18 June 2021

**Re: DEVELOPMENT APPLICATION NO. DA/642/2020 – 11-19 FRENCHMANS ROAD, RANDWICK**  
**APPLICANT'S RESPONSES TO COUNCIL REQUEST FOR INFORMATION AND DESIGN**  
**EXCELLENCE PANEL COMMENTS**  
**AMENDED DEVELOPMENT APPLICATION AND ADDENDUM STATEMENT OF ENVIRONMENTAL**  
**EFFECTS**

This letter has been prepared to respond to each of the matters raised in the meeting notes issued by the Randwick Design Excellence Panel (Randwick DEP) following the meeting held on 8 February 2021, referred to in this letter as the "DEP comments". As a result of the feedback from the Randwick DEP, this has necessitated design amendments to the Development Application (DA), including changes to the architectural drawings and landscape architectural drawings. A list of amended drawings and information are detailed in **Table 1** below. The amended Architectural drawings are included in **Appendix C**. A list of changes is outlined under Section 1.2 below and a summary of comparative changes has been prepared in **Table 5**.

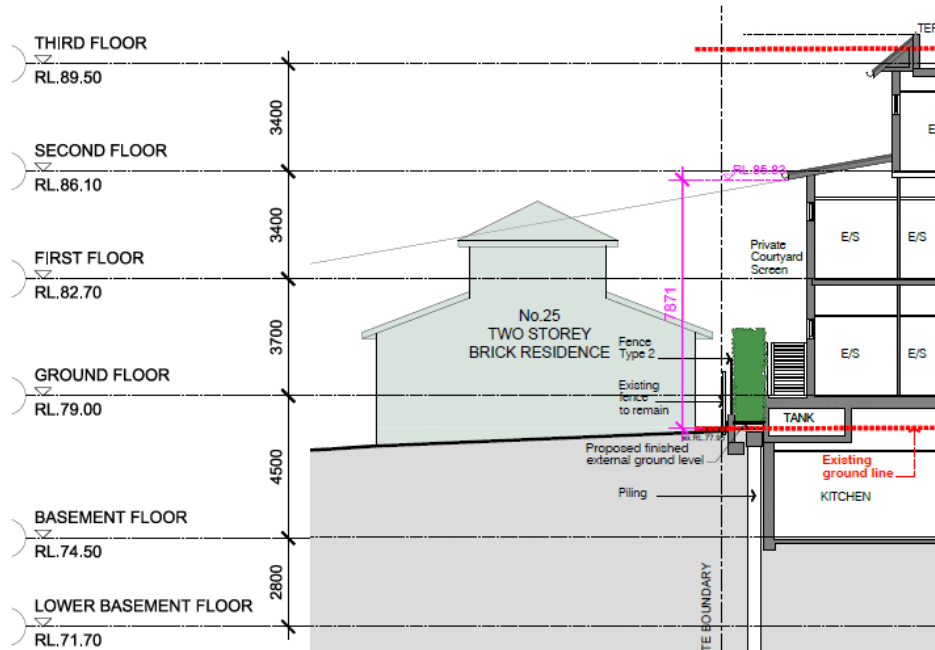
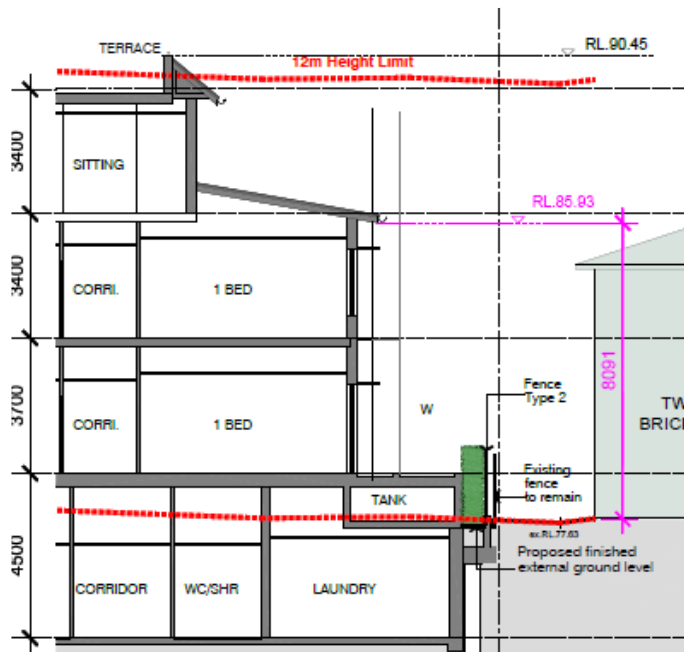
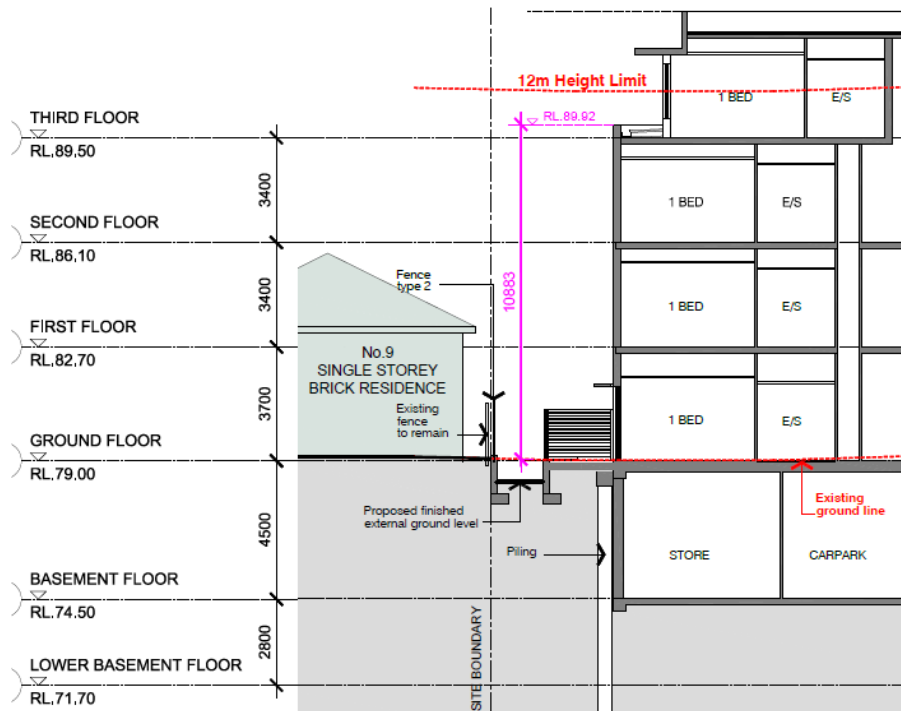
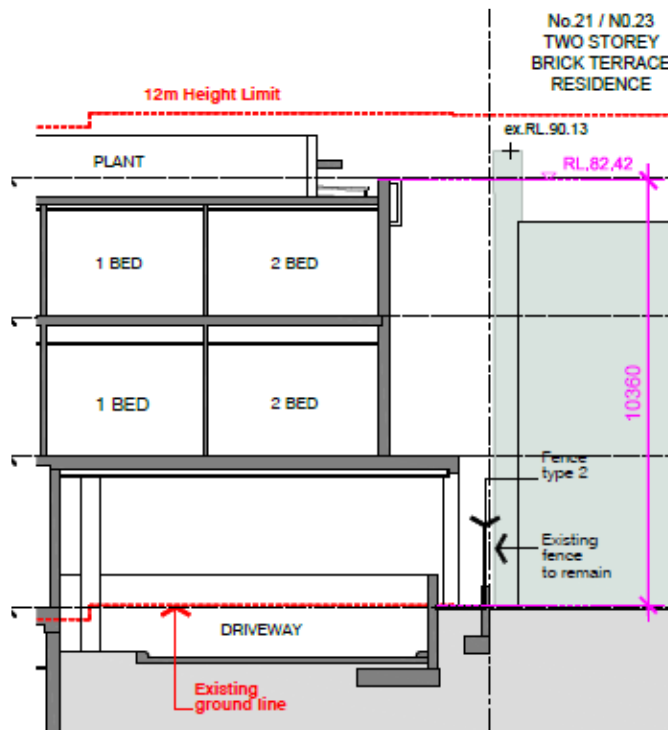
<p><b>Principle 2: Scale and Built Form</b></p> <p><i>The site is zoned R3 with an allowable floorspace ratio of 0.9:1 and a height limit of 12 metres, as well as a DCP wall height of 10.5 metres. The proposal is being submitted under the Seniors Housing SEPP (housing for seniors or people with a disability). This SEPP references the seniors living policy urban design guidelines for infill development.</i></p>	<p>The amended architectural design includes new Drawing No. DA13a which includes an assessment of the height of the walls of the proposed building adjacent to its boundaries have been demonstrated. Row 18 in Table 5 included in <b>Appendix R</b> of this Addendum SEE summaries the wall height and boundary relationships as follows:</p> <ul style="list-style-type: none"> <li>• Section G to eastern boundary with 25 McLennan Ave – wall height 7.871m setback 2.55m, upper-level setback 3.95m</li> <li>• Section J to western boundary with 27 McLennan Ave – wall height 8.091m setback 2.51m, upper-level setback 3.96m</li> <li>• Section K to western boundary with 9 Frenchmans Road – wall height 10.88m setback 4m, upper-level setback 5.5m</li> <li>• Section K to eastern boundary with 21 Frenchmans Road – wall height 10.36m setback 2.35m, upper-level setback 3.85m to plant enclosure</li> </ul> <p>There are no requirements under the Randwick Development Control Plan which apply to a “seniors housing” development. However, to respond to the Randwick DEP feedback this new drawing was prepared to</p>

understand the wall height at the boundaries of the site. Based on this drawing and the summary above, the proposal has been amended so as the wall height complies with the exception of Section K at the western boundary to 9 Frenchmans Road which involves a 33cm variation or 3% variation of this DCP control. The applicant requests Council support the minor variation on this occasion as the proposal remains consistent with the intent of the wall height and does not result in excessive bulk in that location, unacceptable overshadowing and the elevation has been designed so as to avoid loss of privacy or overlooking into 9 Frenchmans Road.

- The wall heights to each boundary have been reduced and amended as detailed in new architectural drawing DA13a as included in **Appendix C** and discussed in detail previously in this Addendum SEE above and Table 5.
